EXECUTIVE ORDER D-44  
Relating to Exemptions under Section 27156  
of the Vehicle Code

FAIRCHILD SEMICONDUCTOR  
"KV ELECTRONIC IGNITION SYSTEM MODEL E 100"

Staff Report

Evaluation of the Fairchild Semiconductor  
"K.V. Electronic Ignition System Model E 100" for Compliance  
with the Requirements of Section 27156 of the California  
Motor Vehicle Code

Figure 1 PEAK COIL SECONDARY OUTPUT VOLTAGE -VS- ENGINE RPM

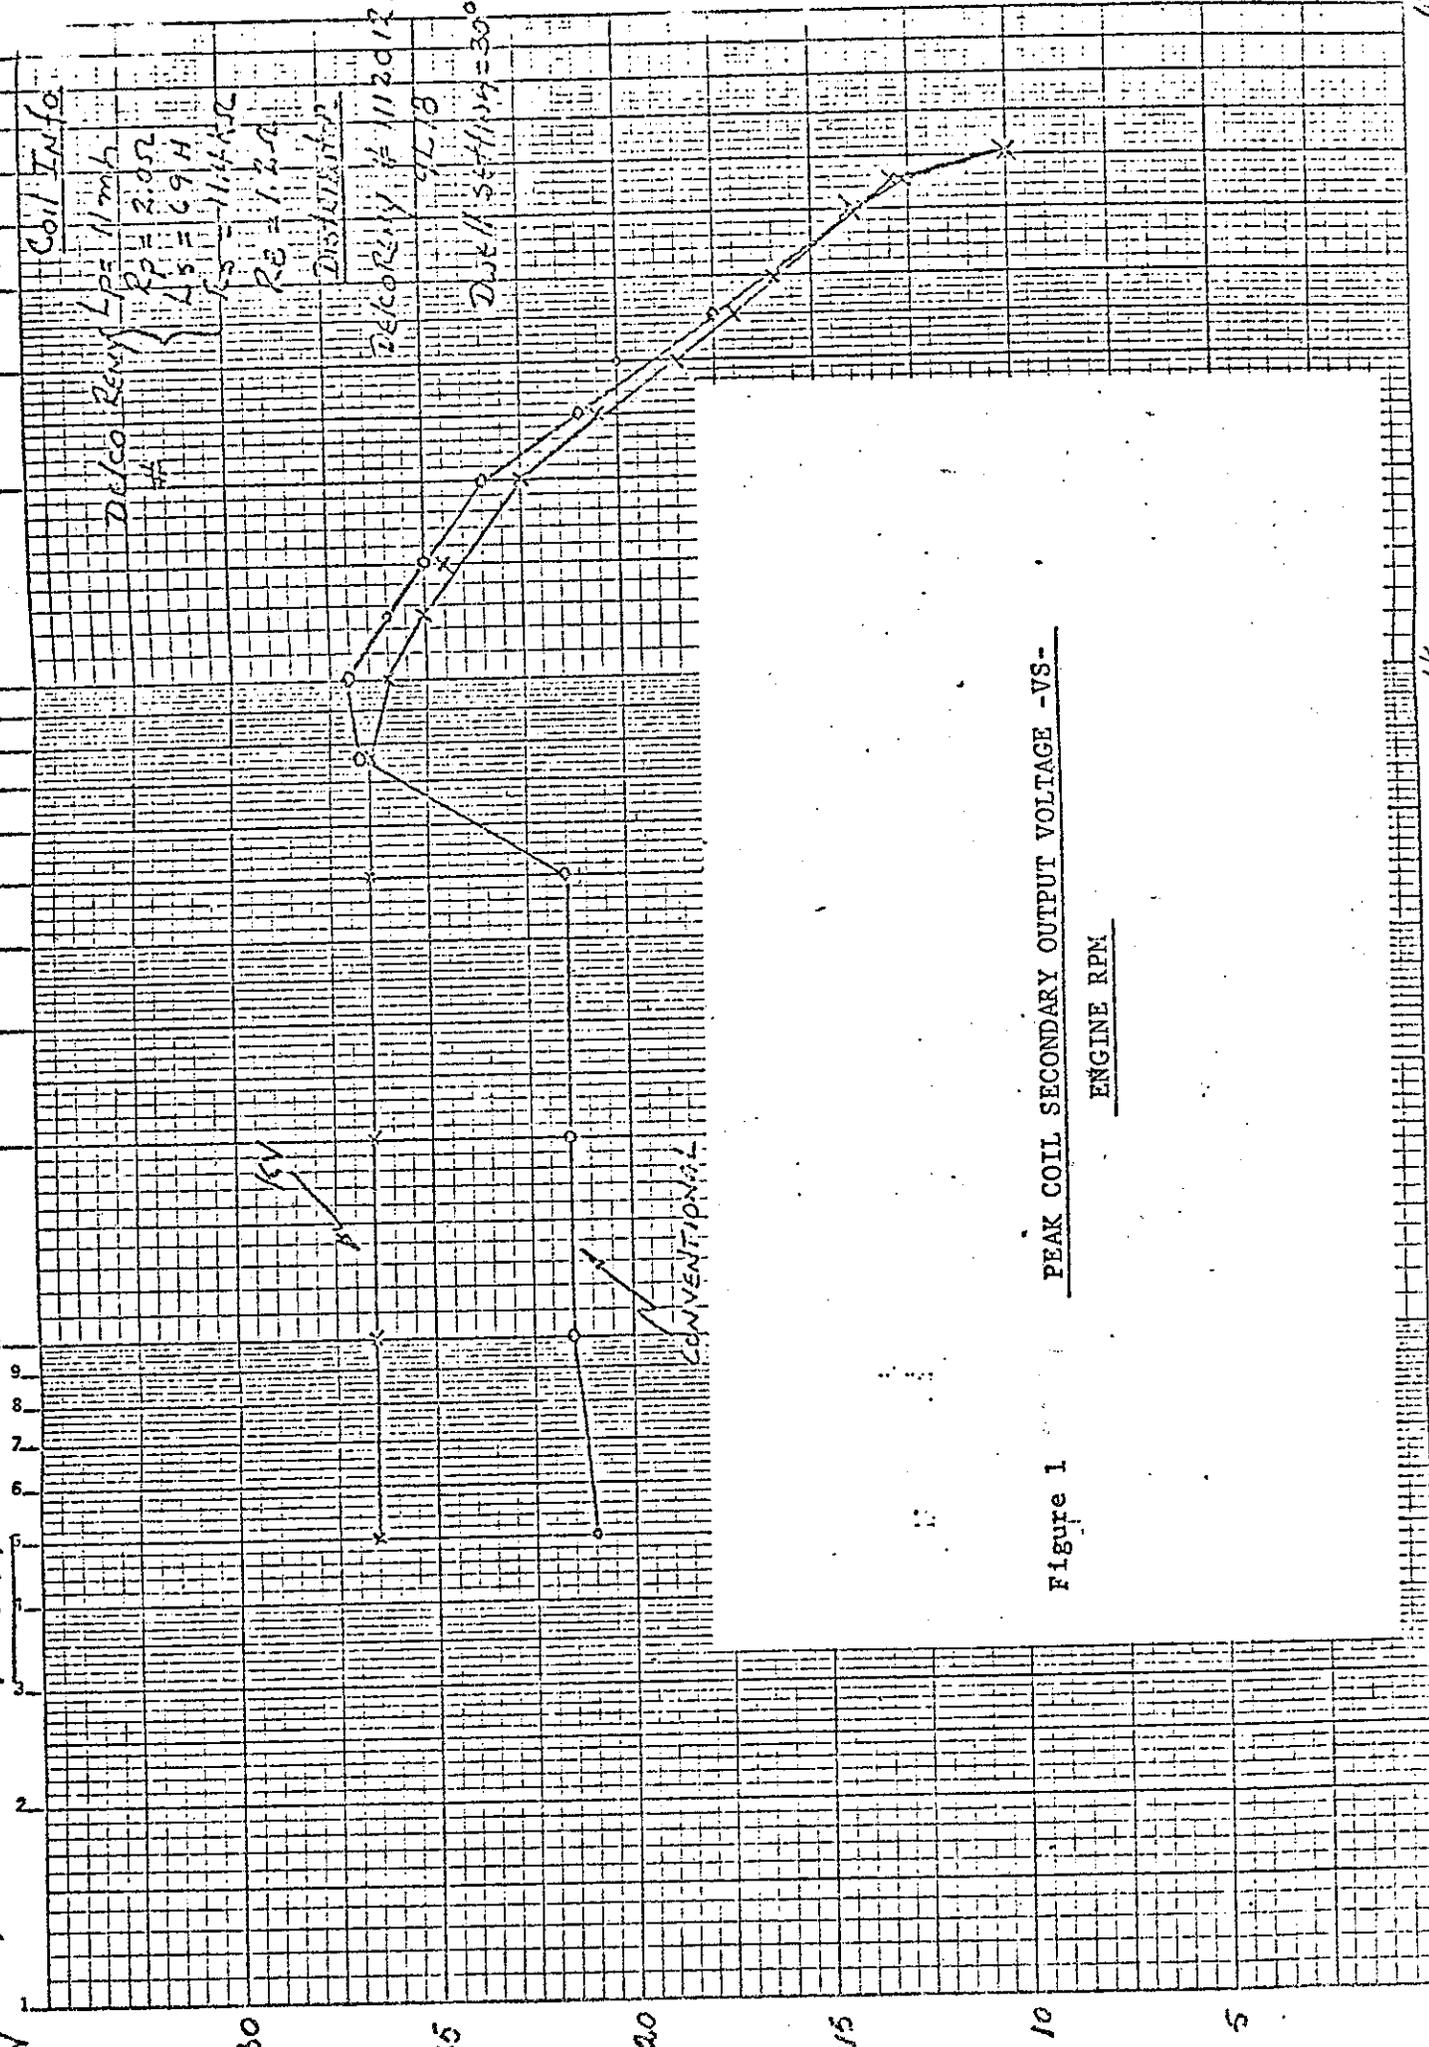
The applicant submitted data (Figure 1) comparing the electrical output of the "KV" device and the stock system. The available secondary voltages off idle is essentially the same. However, higher secondary voltages are encountered at idle and cranking speeds. No noticeable changes to the spark timing occurs with the device. The applicant presented data which show a 20 microsecond delay between the time the points open and the signal propagation from the transistor. This delay resulted in a retarded timing of 0.36 degrees at 3000 rpm. This retard is generally not measurable with common instruments.

One explanation for the differences between the applicant's and ARB secondary voltage data off idle may be due to the conditions of the points. Points that accumulated mileage generally exhibit a greater tendency to arc. The points used by the applicant were new while the points used by the ARB had accumulated 6000 miles. Therefore, the elimination of arching caused by the device would be expected to increase the secondary voltages observed in the ARB test results.
